Plan Commission recommendation to approve an Amendment to Special Use for PUD and PUD Preliminary Plan for Meijer Outlot (Meijer PUD).

RE: Amendment to Special Use for Planned Unit Development & PUD Preliminary Plan –
 Meijer Outlot (Meijer PUD)

Project Name: Meijer Outlot

TREE REMOVAL PLAN

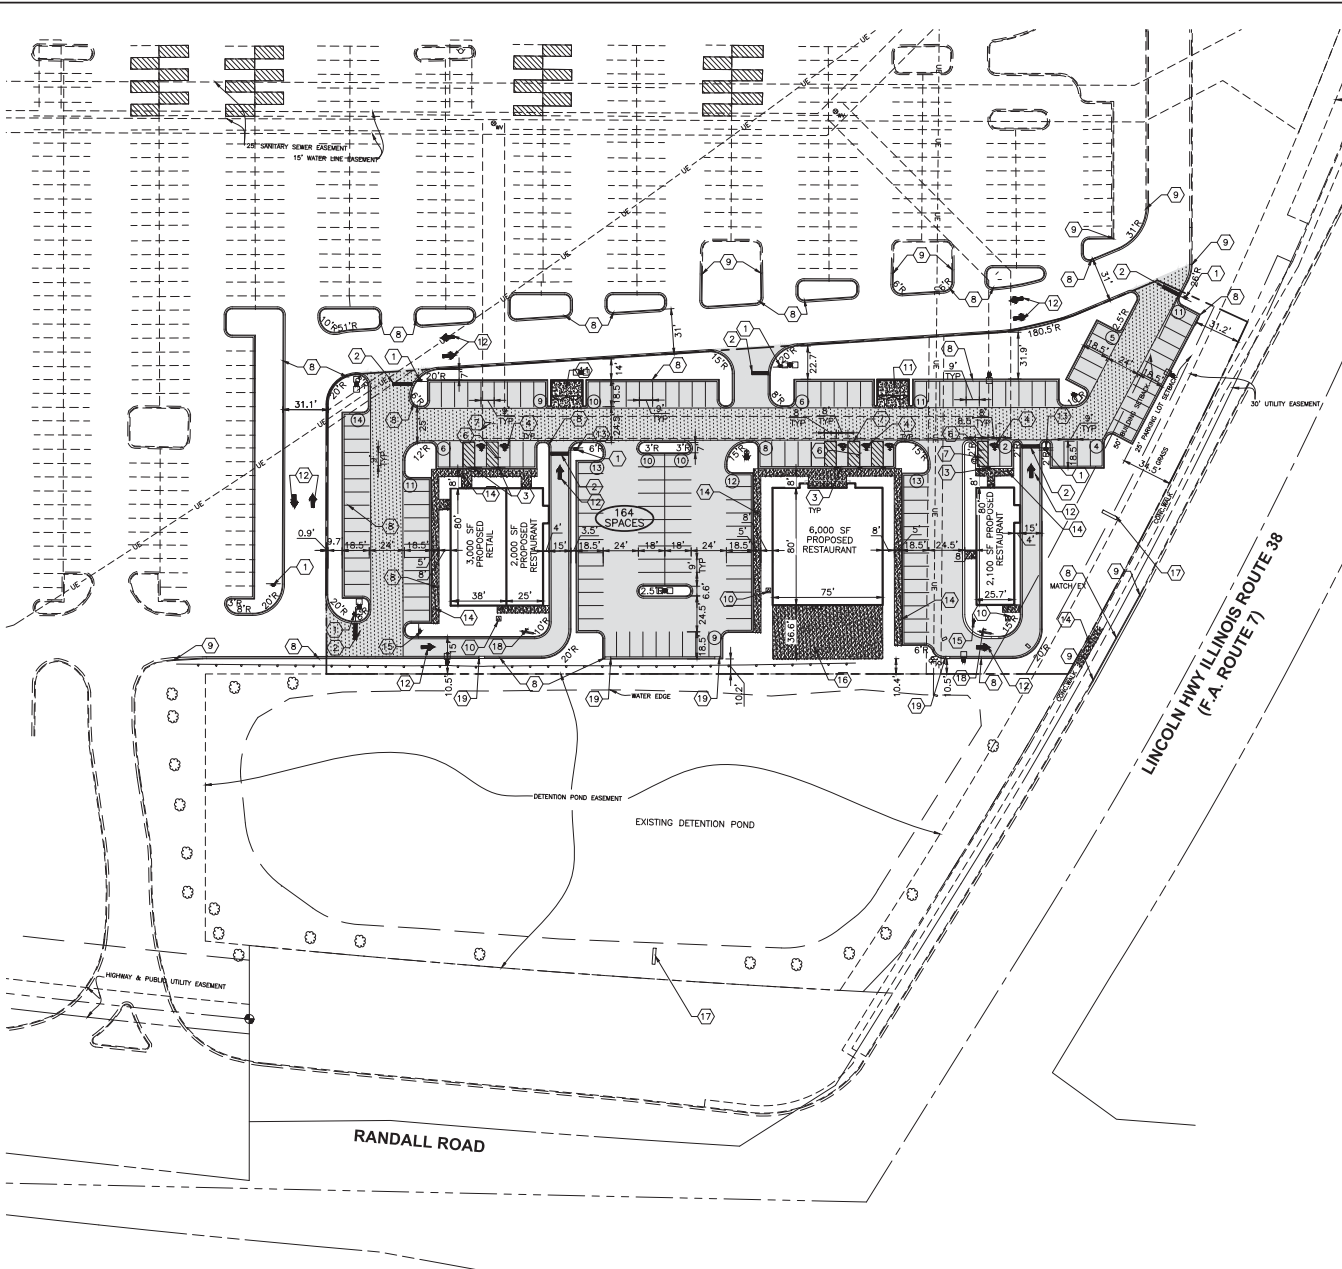
In order to increase visibility of the outlot development from Randall Rd., several trees are proposed to be removed around the adjacent detention basin. A Tree Removal Plan has been provided identifying trees that will be removed and preserved. All evergreen trees will be removed. All trees being preserved are deciduous. Meijer has provided a letter stating their consent to modify the landscaping around the detention basin, as it is on the Meijer property.

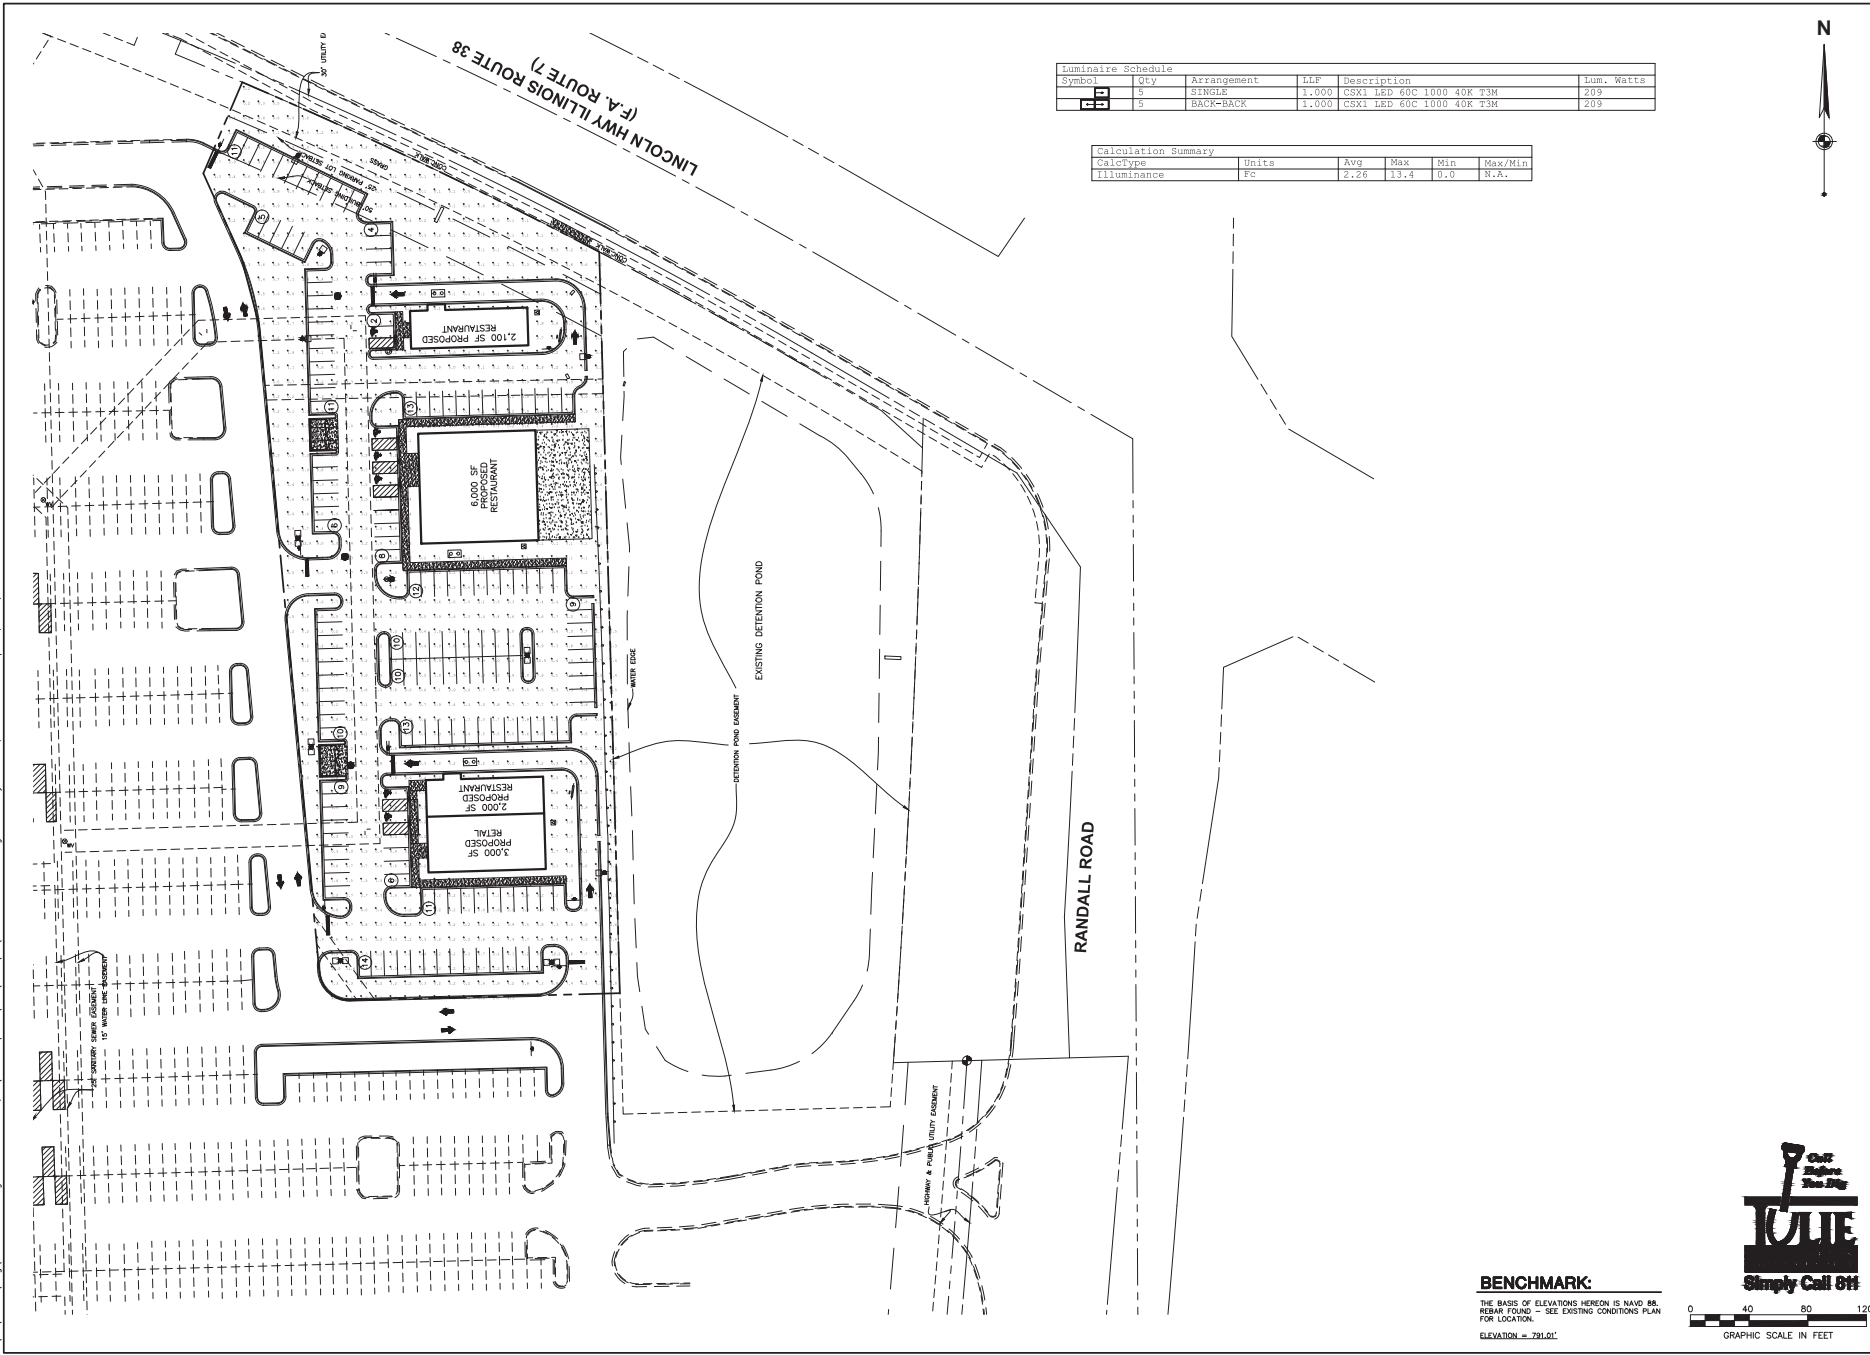
A photometric plan has been submitted. Staff has reviewed the plan for conformance with Section 17.22.040 “Site Lighting”.
